Access Compliance Report

Public Rights-of-Way

(Curb Ramps)

Intersection ID: 41209	Main Street: SACKETT_WY	Cross Street: CLYMER_CT	Location: NE
ADA ID: 49251B10012C	Ramp Type: PerpDiag	Initial Pass/Fail: Fail	Overall Compliance: No
		Severity Score: 8.75

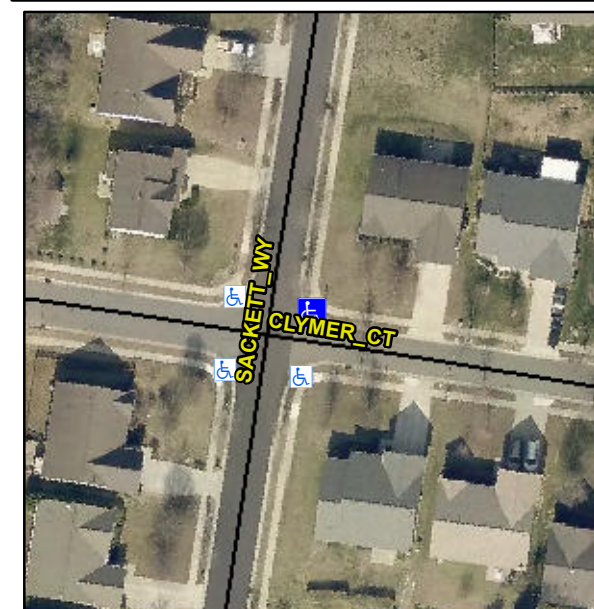
Not Found, R304.5.1

Compliance	Description	Data	Compliance	Description	Data
N/A	Ramp Length (in)	49.0	Yes	Ramp Slope (%)	5.0
No	Ramp Width (in)	44.0	Yes	Ramp XSlope (%)	0.4
N/A	Flare Type LT	N/A	N/A	Flare Type RT	N/A
N/A	Flare Slope LT (%)	N/A	N/A	Flare Slope RT (%)	N/A
N/A	Flare Traversable LT?	N/A	N/A	Flare Traversable RT?	N/A
N/A	Landing Length (in)	N/A	N/A	DWS Provided?	N/A
N/A	Landing Width (in)	N/A	N/A	DWS Contrast?	N/A
N/A	Landing Slope (%)	N/A	N/A	DWS Length (in)	N/A
N/A	Landing X Slope (%)	N/A	N/A	DWS Full Width?	N/A
N/A	Landing Curb? (Y/N)	N/A	N/A	DWS Offset (in)	N/A
N/A	Shared Landing?	N/A			
N/A	Gutter Ponding?	N/A	N/A	Gutter Slope (%)	N/A
N/A	Gutter Lip Ht (in)	N/A	N/A	Gutter X Slope (%)	N/A
N/A	Painted X Walk1?	No	N/A	Painted X Walk2?	No
	X Walk 1 Direction	To W		X Walk 2 Direction	To S
N/A	X Walk 1 Width (in)	N/A	N/A	X Walk 2 Width (in)	N/A
	X Walk 1 Slope (%)	2.1		X Walk 2 Slope (%)	2.0
	X Walk 1 X Slope (%)	2.8		X Walk 2 X Slope (%)	1.9

Remove & Replace Curb Ramp With Two New Directional Ramps or Equivalent.
